WELLS + ASSOCIATES
MEMORANDUM

Re: Columbian Quarter at Poplar Point
Zoning Commission Case No.: 16-29

Date: December 18, 2017

Figure 1
Existing Volume Vs Background Volume
Howard Road

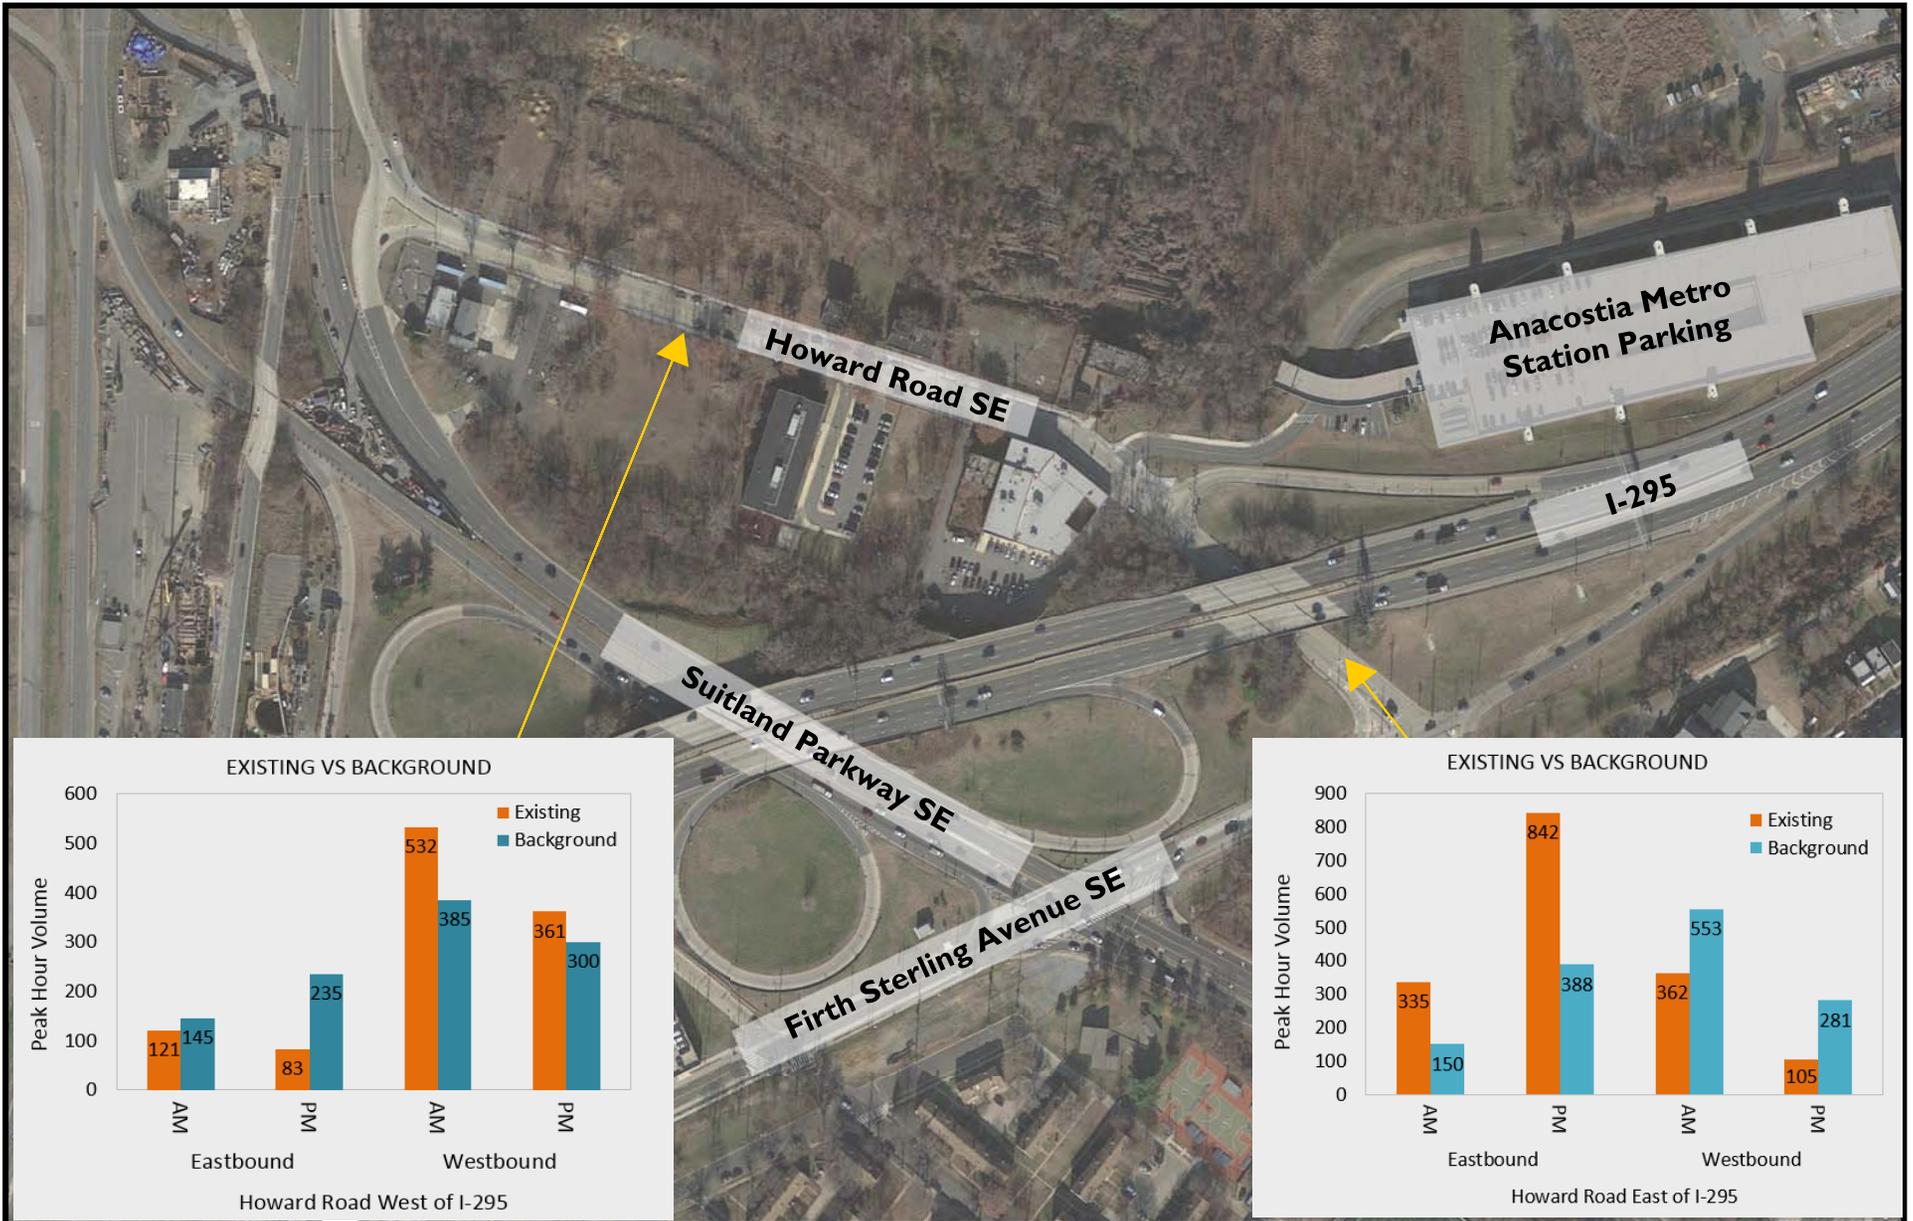
At the public hearing for the above-referenced case on December 4, 2017, Commissioner May requested additional information regarding the traffic impact associated with the removal of the I-295 southbound off-ramp at Howard Road, which is proposed to be removed in conjunction with DDOT's South Capitol Street Improvement Project. In response to his inquiry, Wells + Associates has looked in detail at the existing and projected volumes on Howard Road in the vicinity of the I-295 off-ramp.

Figure 1 illustrates the traffic volumes on two different segments of Howard Road. The first segment is located between Suitland Parkway and the Anacostia Metro Station parking garage. As shown on Figure 1, eastbound traffic volumes are projected to increase by 20 percent during the AM peak hour and by 183 percent during the PM peak hour as the result of the South Capitol Street Improvement Project.¹ The increase in eastbound traffic volumes on this segment results from the fact that traffic exiting I-295 south will exit onto Suitland Parkway in the future rather than Howard Road. A portion of that rerouted traffic will be rerouted westbound on Suitland Parkway and then eastbound on Howard Road. It should be noted that this section of Howard Road is significantly under capacity (i.e. the volume-to-capacity ratio is just 0.22) and, therefore, can accommodate substantial increases in traffic.

Westbound traffic on this segment of Howard Road is projected to decrease by 28 percent during the AM peak hour and by 17 percent during the PM peak hour. This reduction is directly related to the removal of traffic exiting I-295 southbound from Howard Road.

The second roadway segment shown on Figure 1 is located between the Anacostia Metro Station parking garage and Firth Sterling Avenue. On this segment, eastbound traffic volumes are projected to decrease by 55 percent during the AM peak hour and by 54 percent during the PM peak hour. This reduction is directly related to the removal of traffic exiting I-295 southbound from Howard Road.

Westbound traffic on this segment of Howard Road is projected to increase by 53 percent during the AM peak hour and by 168 percent during the PM peak hour. The increase in eastbound traffic volumes on this segment results from the fact that traffic exiting I-295 south will exit onto Suitland Parkway rather than Howard Road. A portion of that rerouted traffic will be rerouted eastbound on Suitland Parkway and then westbound on Howard Road.

As a result of these changes, the removal of the traffic signal at the I-295 SB off-ramp does alleviate a source of delay on Howard Road that results from the traffic signal, which is exacerbated as a result of the close spacing between the signal at the off-ramp and the signal at the Anacostia Metro station entrance (the current spacing is just 100 feet).

The rerouting of traffic associated with the removal of the I-295 SB does increase the traffic volumes through the Suitland Parkway/Howard Road intersection. As a result of that increase, the Applicant has agreed to install a traffic signal at that intersection. In addition to better facilitating vehicular traffic at the intersection, signalization of that intersection also will help facilitate pedestrian crossings at the intersection. While the volume of pedestrians at the intersection currently is minimal, it is expected to increase with the redevelopment of the area.
